RE: Safety Defect and Noncompliance Report for Vehicles, IAW 49 CFR Part 573

On June 28th, 2011 Columbia ParCar Corp. notified the NHTSA that a potential safety defect which relates to motor vehicles governed under authority of NHTSA may exist in the motor vehicles listed in the attached report. Columbia ParCar Corp has identified this recall as SR11-001A.

SAFETY RECALL SR 11-001A

Steering Shaft Splined Yoke Inspection and Replacement

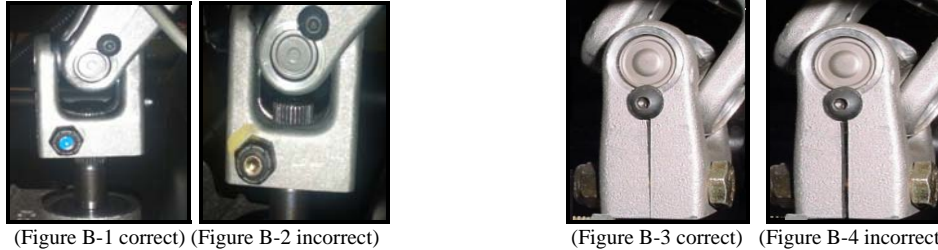
- A) Possible loosening of lower steering yoke, at point of attachment to steering rack pinion, causing spine teeth to strip, which results in slippage of yoke at pinion gear.
- B) Determined cause of defect: Yoke positioning and retaining bolt tightening processes may not have been consistently followed during production, leading to potential inadequate spline coverage and tension at lower steering yoke.

Figure B-1 indicates correct position between steering yoke bottom and steering rack.

Figure B-2 indicates steering yoke mounted too low on steering rack pinion shaft.

Figure B-3 indicates steering yoke bolt properly torqued and compressed.

Figure B-4 indicates steering yoke bolt is not properly torqued or compressed.

1. Inspection of position where steering yoke is fastened to steering rack pinion gear. Clearance between lowest portion of yoke and top of steering rack must be between 15/16" and 1-1/16" inch. If not, lower yoke must be replaced.
2. Measurement of torque on lower steering yoke retaining bolt. This bolt must be a verified grade 8 bolt and properly torqued to 25 ft lbs. If not, lower yoke must be replaced.
3. If position of lower yoke is correct as shown in item 1, and the bolt is properly torqued to 25 ft lbs, no further action is required.

Figure 4 (A,B,C)

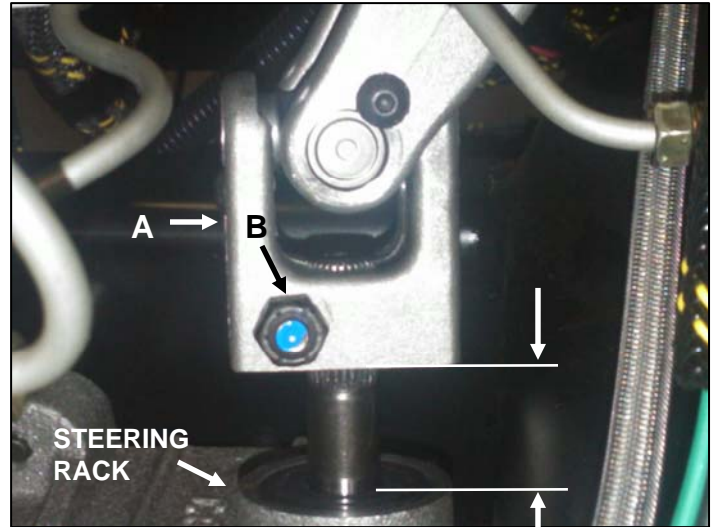
1. See Figure 4. Measure the distance between the bottom of the lower splined yoke (Figure 4A) and the top of the steering rack (Figure 4C). This measurement is to be between 15/16" and 1-1/16".

If this space is between 15/16" and 1-1/16" inspect the torque of the yoke retaining bolt (Figure 4B).

2. If the distance between the bottom of the lower splined yoke and the top of the steering rack is not between 15/16" and 1-1/16" or if the yoke retaining bolt (Figure 4B) torque was found below 25 ft lbs the lower steering yoke must be replaced.

1. Replacement of the lower splined yoke will require removal of the lower section of the steering shaft assembly. Begin by removing the roll pin from the center yoke using a 1/4" straight punch. See Arrow, Figure 5. Discard this roll pin.
2. Next remove and discard the 5/16" nut (Figure 4B) and bolt which attaches the lower splined yoke to the steering rack.

8. With the lower splined yoke properly placed, torque the yoke retaining bolt (Figure 4B) to 25 ft lbs.

Figure 6

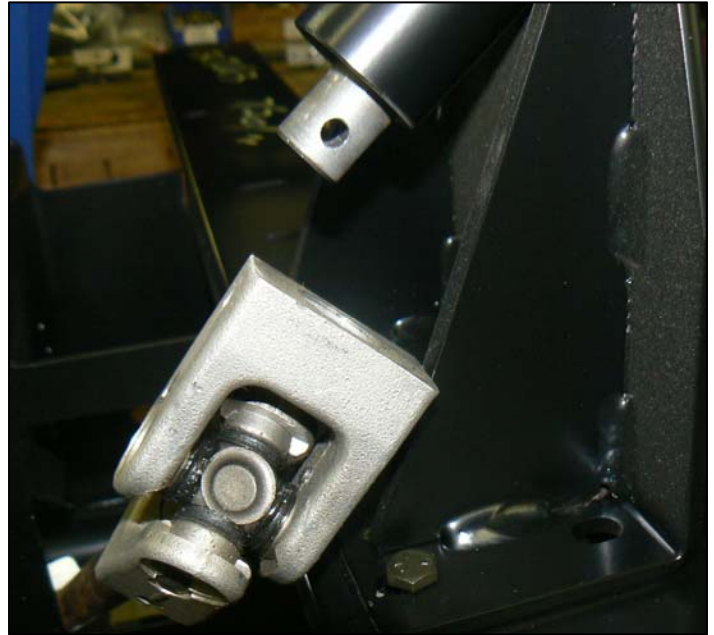
3. To remove the lower section separate the middle yoke from the upper steering shaft and rotate it outward as shown in Figure 6. This will now facilitate removal of the lower section of the steering shaft.

3. From the removed lower section, using a 1/4" straight punch remove the lower splined yoke roll pin and discard the yoke and pin.
4. Replace with a new splined yoke (Item # 1) and new roll pin (Item # 4). and loosely mount this section to the steering rack pinion.

5. Place the middle yoke on the steering tube and secure with a new roll pin (Item # 4).
6. Secure the lower splined yoke to the steering rack using a new bolt (Item # 2) and nut (Item # 3).

Figure 7

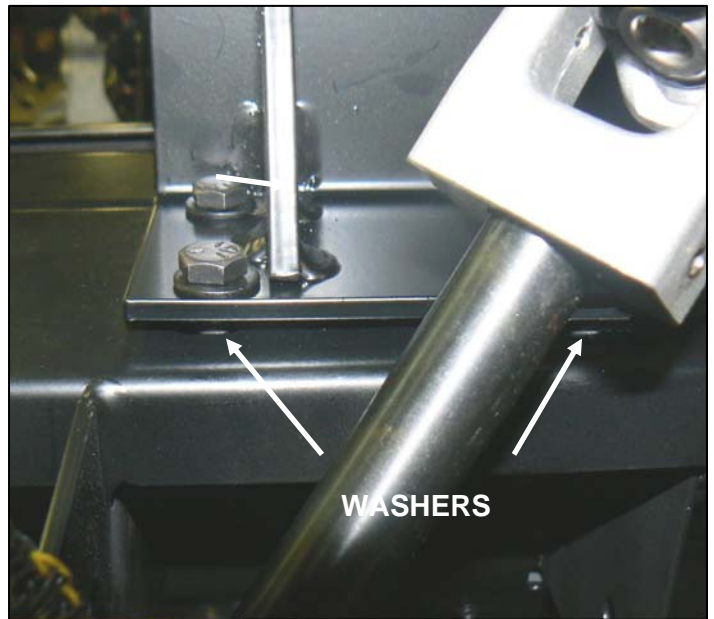
7. Make sure the space between the bottom of the splined yoke and the top of the steering rack is between 15/16" and 1-1/16". *NOTE:* If the 15/16" measurement can not be reached, washers (Item # 5) need to be placed under the steering column bracket at the front two positions. See Figure 7.
